STAFF RECOMMENDATION

315 South 11th Street
June 19th, 2013

Application: New Construction— Dormer Additions
District: Lockeland Springs-East End Neighborhood Conservation Zoning Overlay
Council District: 06
Map and Parcel Number: 08313017300
Applicant: Ferrell R. Gamble, Contractor
Project Lead: Fred Zahn, fred.zahn@nashville.gov

Figure 1. 315 S. 11th Street

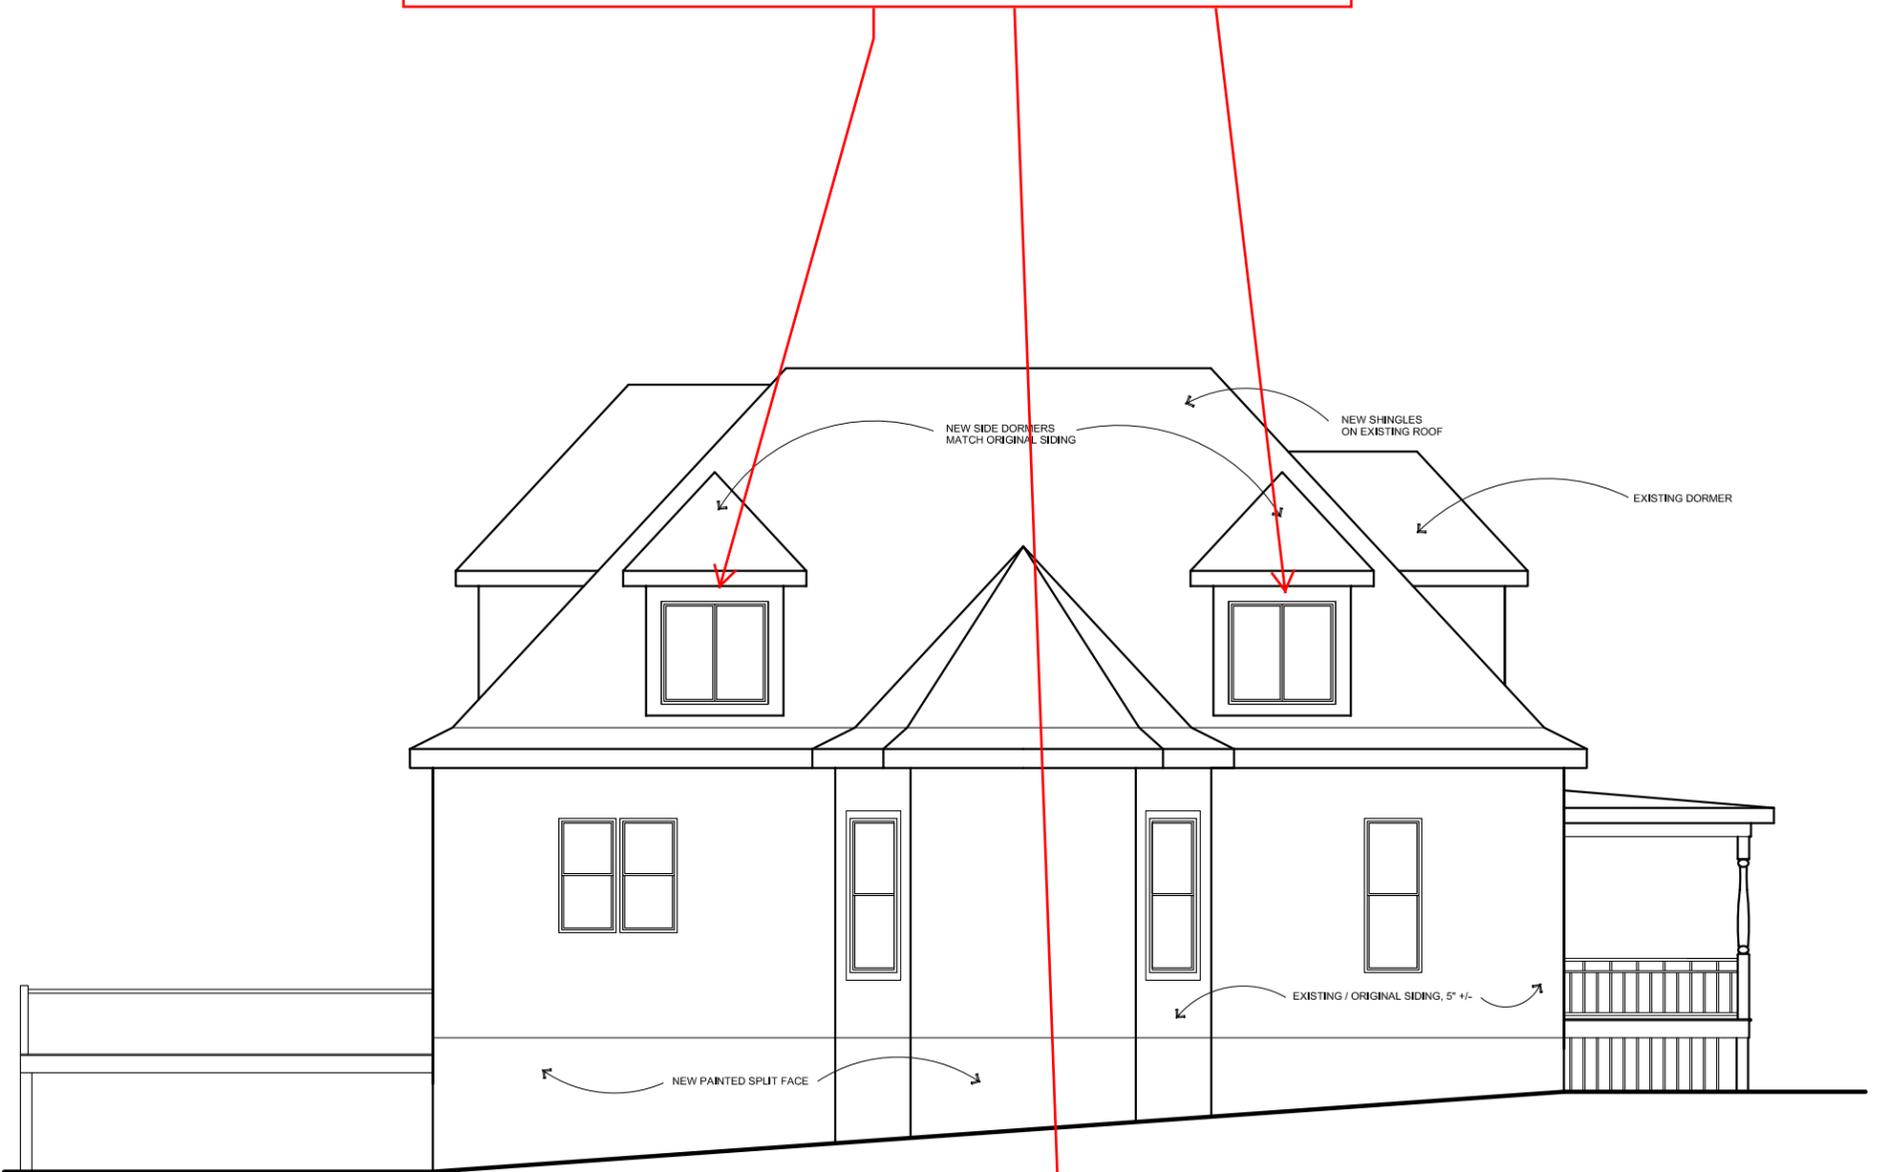
Background: 315 South 11th Street is a wood-frame Victorian house constructed c. 1910 (see Figure 1). It is contributing to the Lockeland Springs-East End Neighborhood Conservation Zoning Overlay.

LEFT ELEVATION

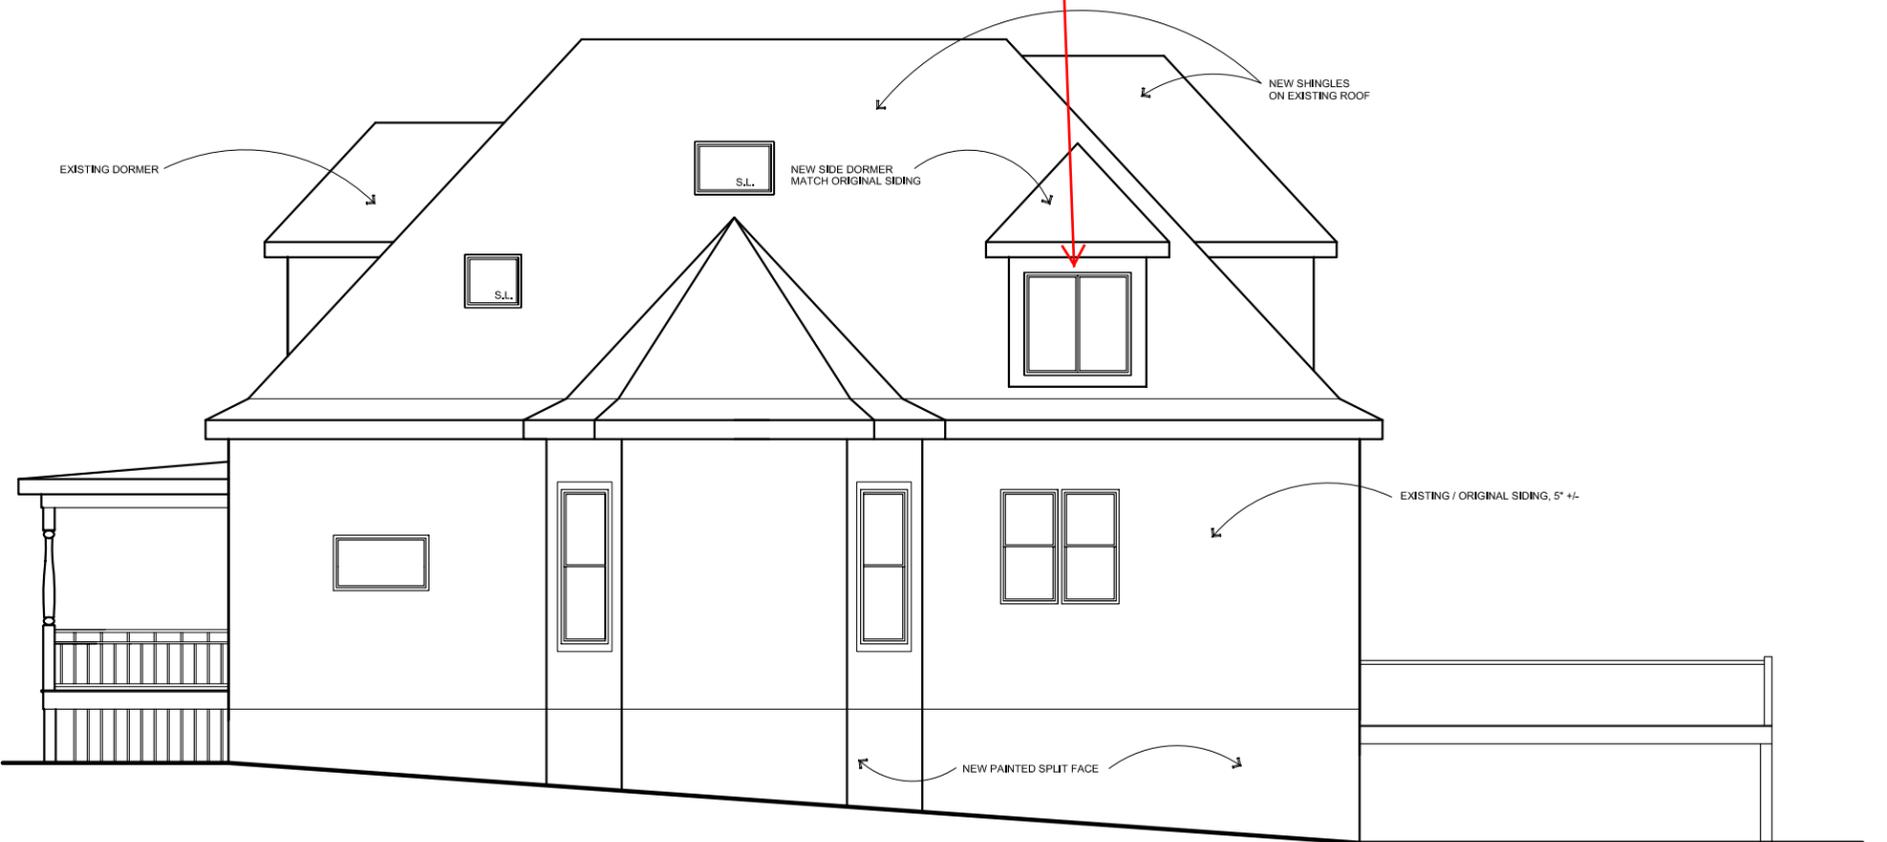
Side Dormers: Two left side dormers and one right side dormer are all similar in design and scale to an existing historic front dormer although the three new structures are all smaller in width at six feet (6'), and one foot (1') lower in ridge height, as compared to the existing historic example which is seven feet nine inches (7'9") in width. The faces of all three new side dormer additions are set back two feet (2') from the planes of the first floor walls below. The roofs of all three new dormers are hipped in design which matches the design of the existing historic front dormer, and all tie-in to the main roof such that there is no damage or disruption to the hip rafters of the main roof. Staff finds that the dormers size and location are appropriate to the style and design of the historic structure. The dormer's eave depth will match that of the existing historic example. The dormers will be

clad in cement fiberboard or wood siding. Staff finds that the dormers meet Sections II.B.2., II.B.5., and II.B.10. of the *Lockeland Spring-East End Neighborhood Conservation Zoning Overlay: Handbook and Design Guidelines*.

All new paired windows MUST incorporate a central 4-6" mullion.

REAR ELEVATION

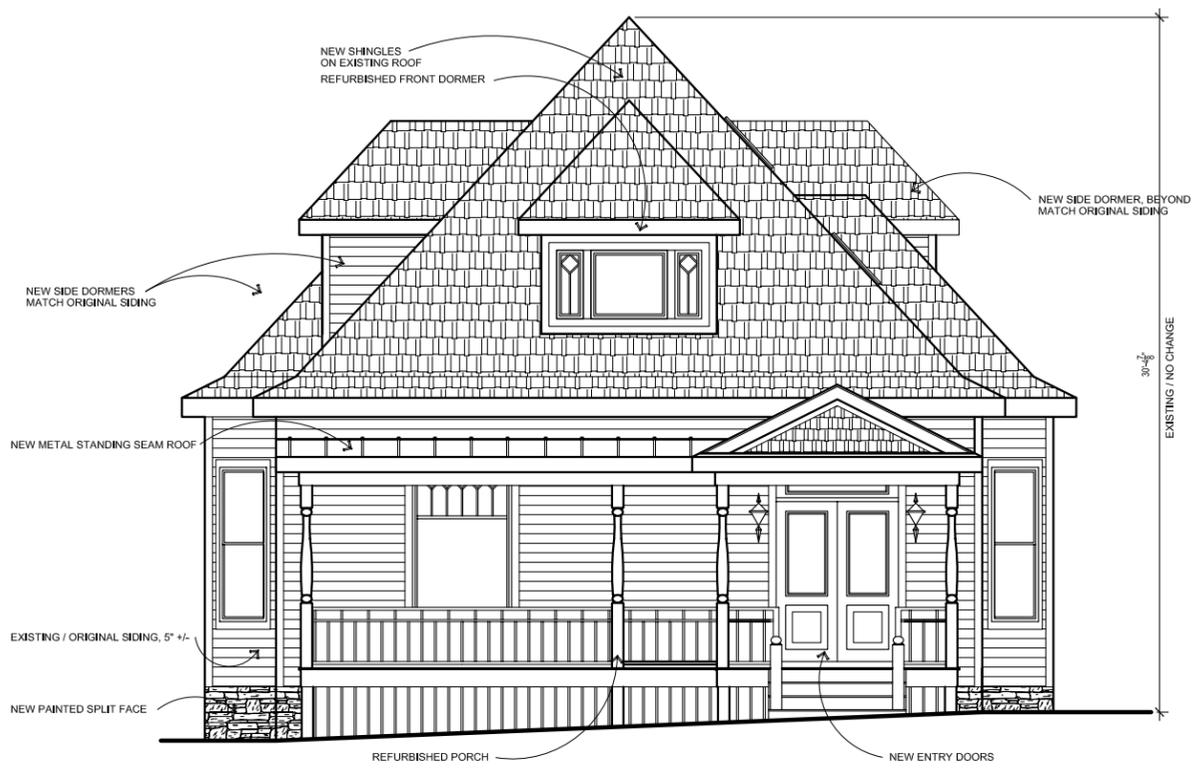
Rear Dormer: The rear dormer will be at most minimally visible from the street. It's face will be fourteen feet, six inches (14' 6") wide and six feet (6') tall. The dormer face is set back two feet (2') from the plane of the side wall below. The roof is hipped in style and is inset from the rear roof plane such that it's ridge is one foot (1') below the ridge of the main roof and the new dormer roof tie-in to the main roof is such that there is no damage or disruption to the hip rafters of the main roof. The dormer will be clad in cement fiberboard or wood siding. Staff finds that the rear dormer meets Sections II.B.2., II.B.5., and II.B.10. of the *Lockeland Spring-East End Neighborhood Conservation Zoning Overlay: Handbook and Design Guidelines*.

Staff finds that the rear addition meets Sections II.B.1., II.B.2., II.B.4, II.B.5., II.B.7., and II.B.10. of the *Lockeland Spring-East End Neighborhood Conservation Zoning Overlay: Handbook and Design Guidelines*.
